MEMORANDUM

Subject: Amended Site Plan and Subdivision Applications – PB 21-30
Saw Mill Stone and Masonry Supply
34-40, 50, 00 & 10 Saw Mill River Road, Hastings, NY
Traffic and Parking Review

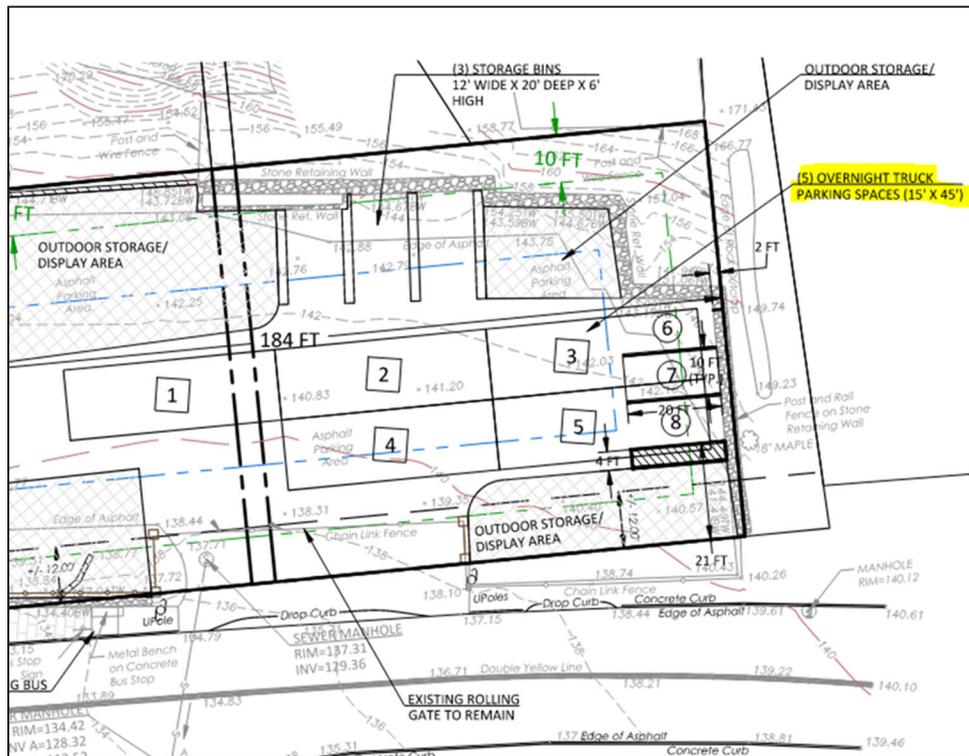
The site plan also shows 5 overnight parking spaces at the southern end of the property, with 2 of these spaces overlapping with the 3 standard spaces (see excerpt from site plan below). **The Applicant should provide details on how the overnight truck spaces will be managed so as not to interfere with the daytime operations of the site.**

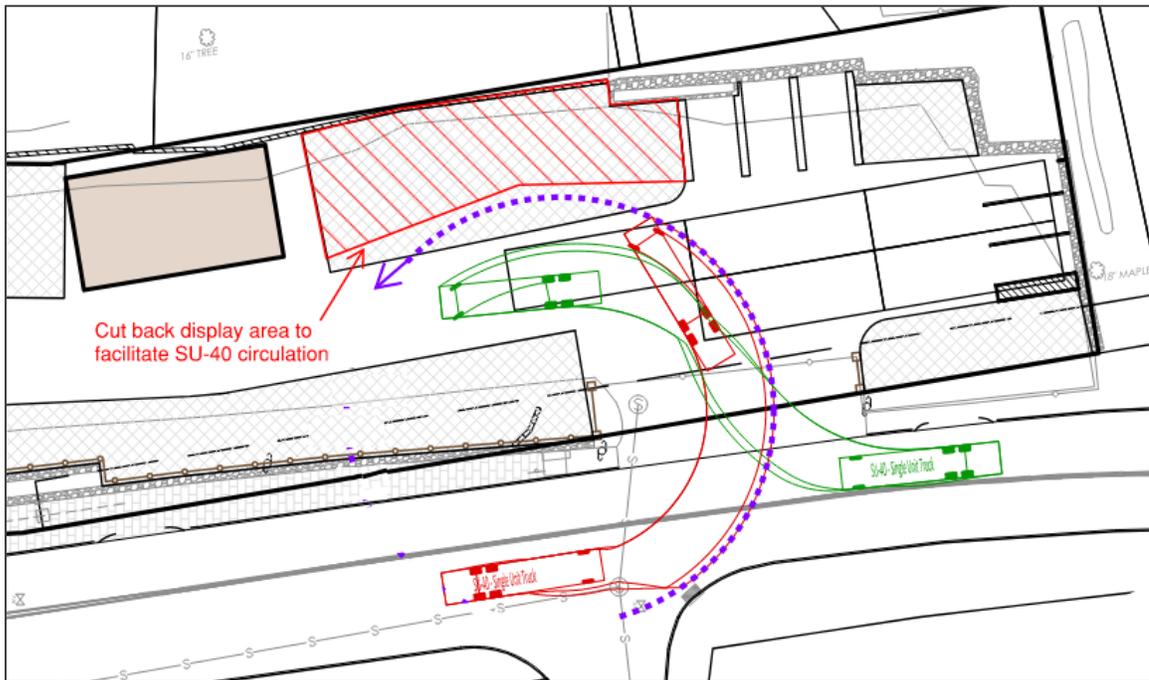
Our initial review of the plan showing an SU-40 turning left into the site at the southern driveway reveals that the truck will be impeded by the storage/display area on the east side of the property. It is recommended that the display area be cut back (as shown in red below) to allow trucks to enter the site in one movement.
